ASSESSMENT REPORT

Commercial and Retail Development – Mount Street, North Sydney MP 08_0241 MOD 6

Figure 3: Level 35 floor plan - approved (above) and proposed (below). (Source: approved and proposed plans)

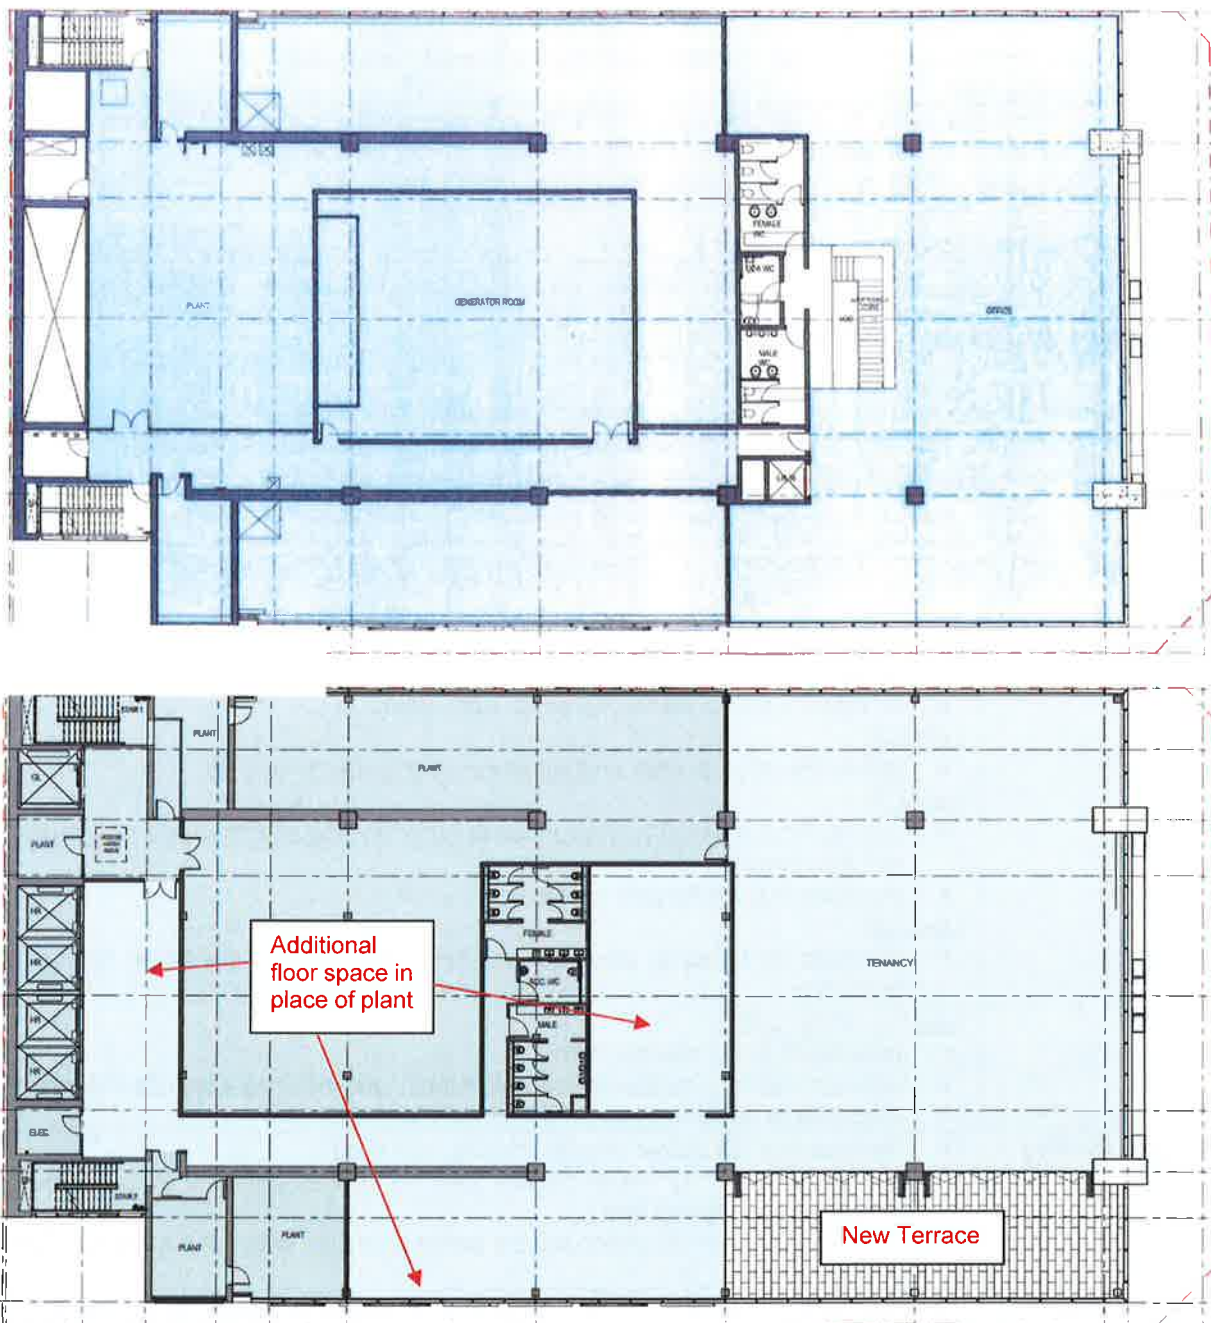
<i>Changes to Floor Layout</i>	<p><u>Ground Level</u></p> <ul style="list-style-type: none"> • Increase width of north and south entry stairs; <p><u>Level 34</u></p> <ul style="list-style-type: none"> • delete the internal stair and lift connecting levels 34 and 35; <p><u>Level 35</u></p> <ul style="list-style-type: none"> • change floor plan to incorporate an outdoor terrace and provide a new multi-function space; • changes to building service areas; <p><u>Level 36</u></p> <ul style="list-style-type: none"> • changes to building services including mechanical, electrical, fire and hydraulic; <p><u>Level 37 (Roof Level)</u></p> <ul style="list-style-type: none"> • provide lift motor rooms; and • relocate building maintenance unit (BMU) and building services including mechanical, electrical, fire and hydraulic services.
<i>Bicycle Parking</i>	<ul style="list-style-type: none"> • Redistribute the visitor bicycle parking, including: <ul style="list-style-type: none"> - retention of 12 visitor bicycle parking spaces adjacent to the Mount Street entrance; and - relocation of 26 visitor bicycle parking spaces within the basement on Level B2.

<i>Increase in Gross Floor Area</i>	<ul style="list-style-type: none"> The proposed modification would result in an increase of GFA from 47,186 m² to 47,450 m² (additional 264 m² or 0.5%). The increase in GFA is a result of the provision of a multi-function space and its associated facilities on the new Level 35 in place of plant. No objection was raised by Council regarding the proposed increase in GFA. Concerns were raised in the public submission that the proposed increase in GFA would exacerbate the bulk and scale of the building. The Department has considered the proposed increase in GFA and is satisfied the proposal is acceptable on the basis that: 	The Department has recommended modified conditions relating to monetary contributions (conditions B5 and B6).

Figure 4: Roof level sections - approved (above) and proposed (below). (Source: approved and proposed plans).

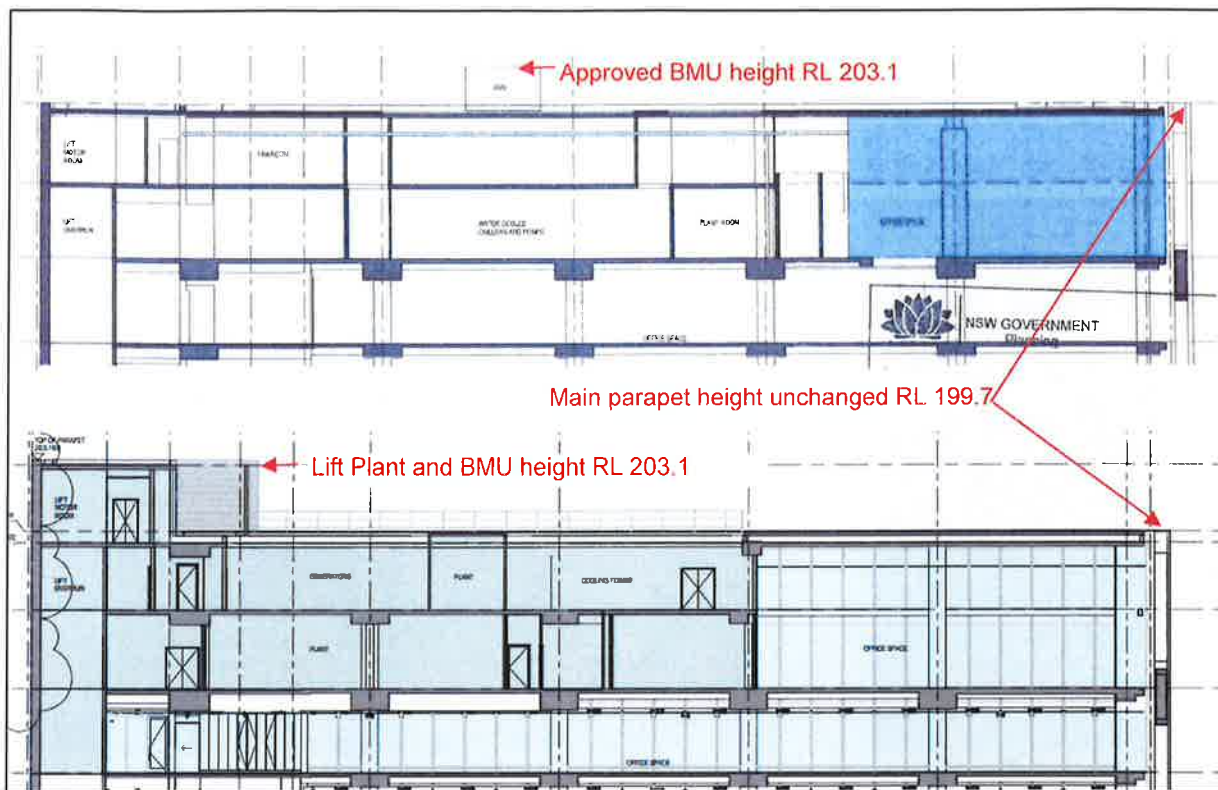
Issue	Consideration	Recommendation
<i>Additional roof level plant and services</i>	<ul style="list-style-type: none"> The proposed modification seeks to increase the extent of roof level plant and services, with the enlarged plant and service area re-located to the western edge of the building. Concern is raised in the public submission that the proposal would exacerbate the non-compliance with Council's height controls, set an undesirable precedent for other building sites and result in amenity impacts in terms of loss of solar access, views, increased overlooking and sense of enclosure. Council have raised no concern with the proposed roof level changes. The Department notes a maximum height control of RL 195 applies to the site under North Sydney Local Environmental Plan 2013 (NSLEP 2013), however roof level plant to a height of RL 203.1 has already been approved on the site. The proposal does not seek to increase the maximum building height in this regard. The Department acknowledges the enlarged and relocated service area would be more readily visible than the existing approved roof level plant. However, the Department is satisfied that the proposal would not result in any unacceptable impacts, noting that: <ul style="list-style-type: none"> the revisions relate only to a small section at the western edge of the building and incorporate the approved façade materials and finishes so that as viewed from the street level and from other vantage points, the change to the overall appearance of the building would be minor and not readily discernible; as viewed from the Beau Monde Building, the proposed changes to the western edge of the site are likely to be obstructed from view by an approved new development at 1 Denison Street, located between the two sites; as a separation of 130 metres exists between the site, and the Beau Monde Building, the proposed minor changes would not result in any unacceptable amenity impacts in terms of loss of solar access, views, increased overlooking or sense of enclosure; shadow diagrams indicate that the proposed changes would not result in any additional overshadowing of residential dwellings or material impacts to public domain areas; a wind report submitted with the modification demonstrates that proposed minor changes would have a negligible impact on the pedestrian level wind conditions; and the building form would continue to be compatible with the dense commercial built form context of the North Sydney CBD. The Department is therefore satisfied the proposed minor changes to the roof level plant are acceptable in this case. 	No additional conditions or amendments necessary.

Figure 6: Western elevation - approved (left) and proposed (right). (Source: Approved and proposed plans).

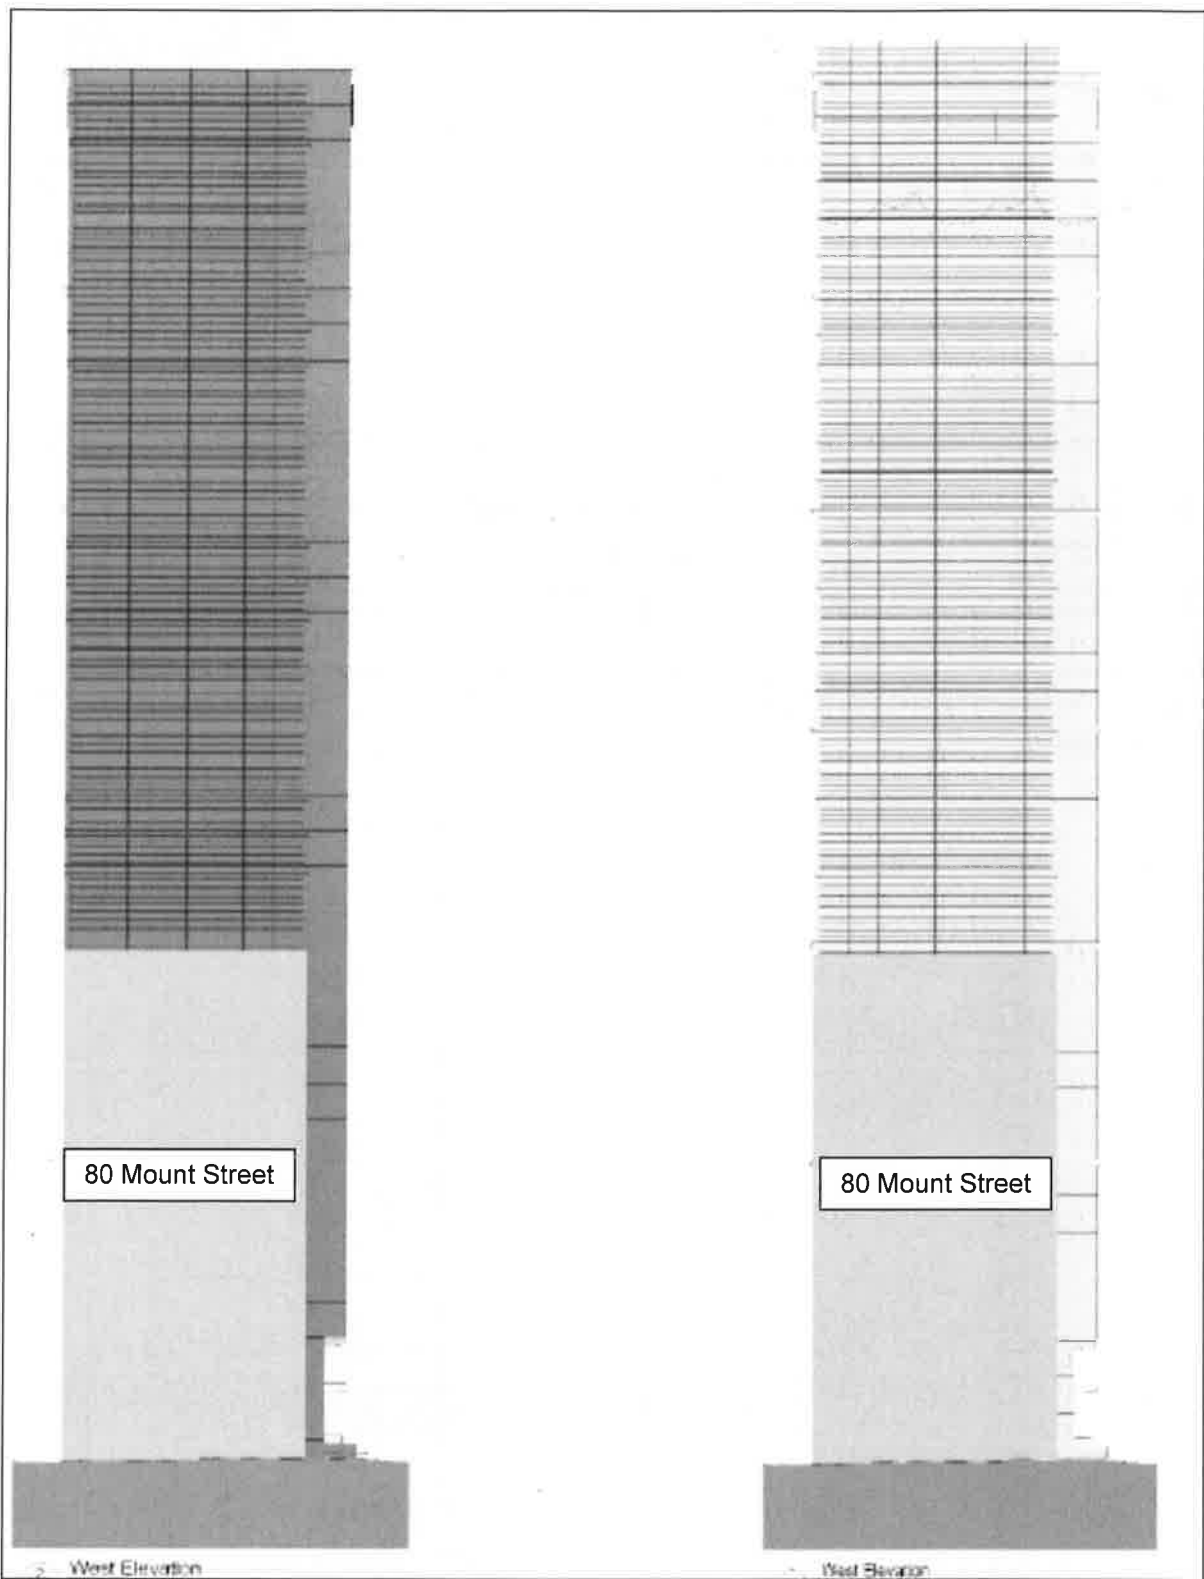
<i>Building Facade</i>	The proposed modifications include minor change to the façade at the top level of the building to accommodate the building services and lift overrun at Level 37.
